AMENDMENTS TO THE DRAWINGS

Attorney Docket No. 42390P12279 Application Serial No. 10/039,374

42390P12279 VOLTAGE CONTROLLER FOR A HIGHLY LINEAR PHASE INTERPOLATOR ROBERT C. GLENN, et al.

FIGURE 1

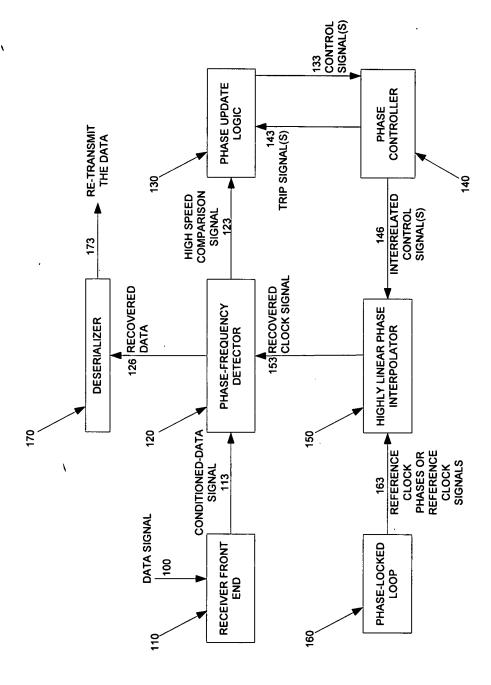
The attached drawing sheet includes changes to Figure 1. This sheet replaces the original sheet including Figure 1. In Figure 1 component labeling and signal flow directions have been updated to be consistent with the specification.
